**UNITED STATES
NUCLEAR REGULATORY COMMISSION ADVISORY
COMMITTEE ON REACTOR SAFEGUARDS
WASHINGTON, DC 20555 - 0001**

SUBJECT: CERTIFIED MINUTES OF THE ACRS U.S. EPR
SUBCOMMITTEE MEETING ON NOVEMBER 6, 2013,
ROCKVILLE, MARYLAND

ADVISORY COMMITTEE ON REACTOR SAFEGUARDS
MINUTES OF THE ACRS US-EPR SUBCOMMITTEE MEETING
NOVEMBER 6, 2013

The purpose of the meeting was to hear presentations and discuss the information contained in Chapter 2, "*Site Characteristics*," Section 2.4, and Chapter 9, "*Auxiliary Systems*," of the Safety Evaluation Report (SER) with Open Items related to the review of the Calvert Cliffs Unit 3 Combined Operating License Application (COLA) FSAR, which references the U.S. EPR DCD.

Figure 2.4-33— {Schematic Diagram Wave Runup on the UHS Makeup Water Intake Structure (MWIS)}

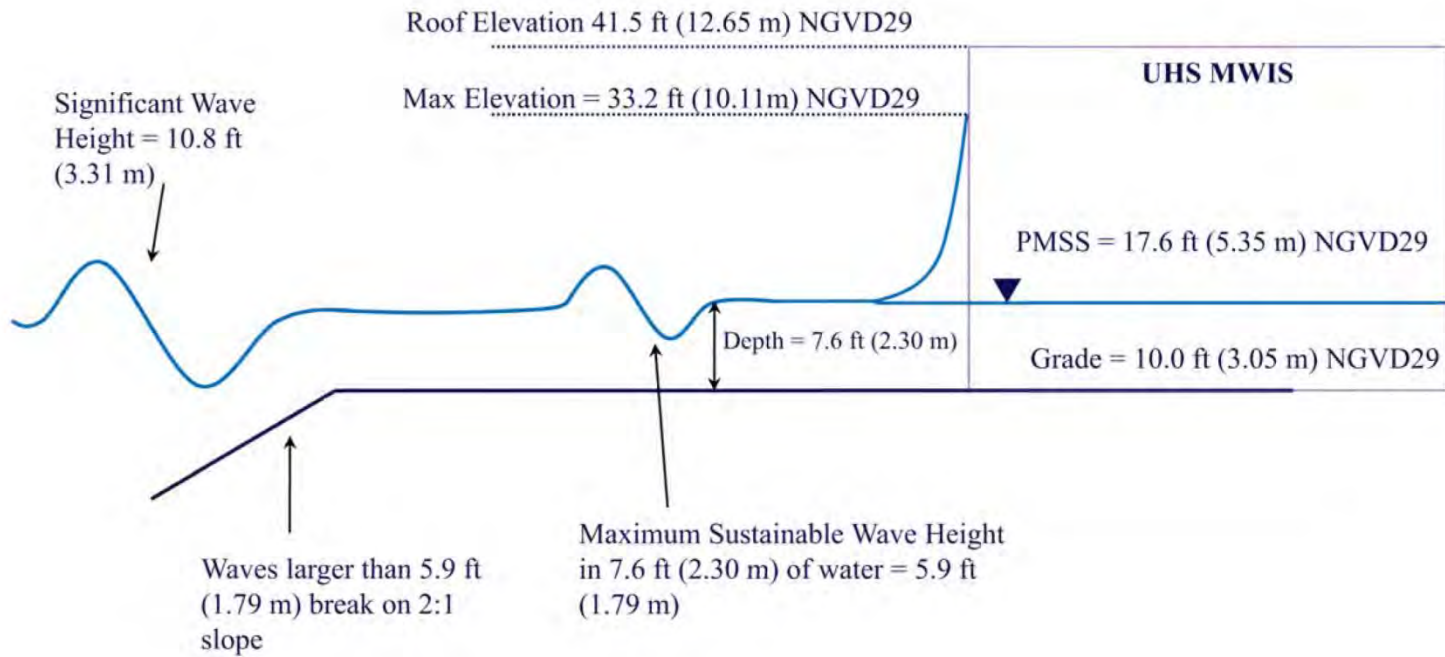
12 MEMBER STETKAR: Yes, okay. If we can go
13 back to 18, your picture of the building. We kind of
14 talked a little bit about storm surges and things. One
15 of the questions I had, which is a building question, is
16 that if you look at the elevations on this slide which
17 obviously you can't see on the screen there, but the storm
18 surge elevation is well above the floor level of the pump
19 and electrical equipment which is nominally, grade
20 level's ten feet, it's like 11-1/2 feet, I think, the
21 floor levels if I remember right. It is stated
22 in the -- most pump rooms I've been in, this is obviously
23 not most pump rooms. The suction piping that comes up
24 through the floor is typically, you know, you can look
25 down and see water down there because you need clearances

16 MR. FINLEY: And actually, just before
17 answering maybe just to show on the figure, John, right
18 in the center of the figure you can see the vertical pump
19 Dr. Stetkar's talking about, and then the floor where the
20 suction line of the pump penetrates. That's, I think,
21 the --
